We would like to thank a lot the reviewers for their very positive comments and good suggestions. Thank you for taking the time to read it carefully and apologies for the length of the paper. We have considered all the comments. See our detailed answers hereafter.

Answer to Anonymous Referee #1

Figure S1: Typical column averaging kernels for TROPOMI, OMI and MAXDOAS instruments on 1 July 2020 over Xianghe.

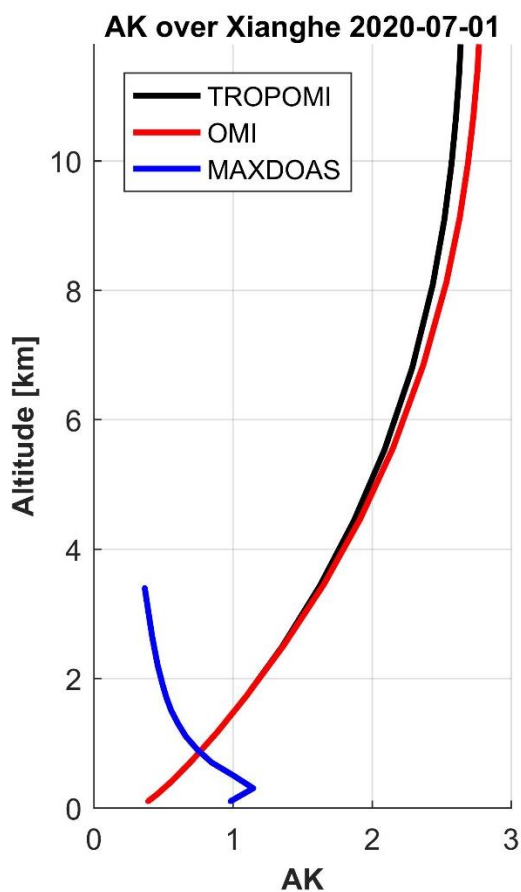
The vertical sensitivity of OMI and TROPOMI on individual scenes are unfortunately not discussed. It would have been very interesting to compare, e.g., the OMI and TROPOMI averaging kernels in typical observational conditions in order to know whether TROPOMI allows probing the tropospheric layers closer to the surface. Although the manuscript is already quite long, perhaps a discussion can be added in this regard.

The vertical sensitivity of OMI and TROPOMI is very similar. The observation angles and overpass times are the same. We do not expect any significant differences. Only the selection of the pixels could lead to small differences, since a number of nadir OMI observations have to be discarded because of the row anomaly. We added this information in the paper (line 609). We have added a figure in the supplement showing typical averaging kernels for OMI, TROPOMI and the MAX-DOAS instrument in Xianghe.

“We see in **Error! Reference source not found.** that at the cleanest site (Uccle) the effect of the smoothing is small, while at the more polluted sites Xianghe and UNAM, the biases are strongly reduced by about 20%. This result is in agreement with previous MAX-DOAS validation studies (De Smedt et al., 2015; Wang et al., 2019b), but also with aircraft and regional model comparisons (Zhu et al., 2020; Su et al., 2020). The effect of the smoothing is also clearly seen in **Error! Reference source not found.** where the scatter plots of daily comparisons between TROPOMI and MAX-DOAS are shown before and after vertical smoothing. The strong effect of the smoothing is usually not observed with FTIR comparisons because TROPOMI and FTIR measurements have similar vertical sensitivity, which rapidly drops in the atmospheric layers lower than 3km (Vigouroux et al., 2020), while the MAX-DOAS shows an opposite sensitivity that is maximum at the surface and generally becomes negligible above 3km (Vigouroux et al., 2008; De Smedt et al., 2015; Wang et al., 2019a). An illustration of typical averaging kernels for OMI, TROPOMI and the MAX_DOAS instrument in Xianghe is provided in Figure S6. As the observation angles and overpass times are very close for OMI and TROPOMI, their measurements come with a similar vertical sensitivity. This highlights the importance of taking into account the different a priori profiles and averaging kernels when comparing techniques having different vertical sensitivity.”
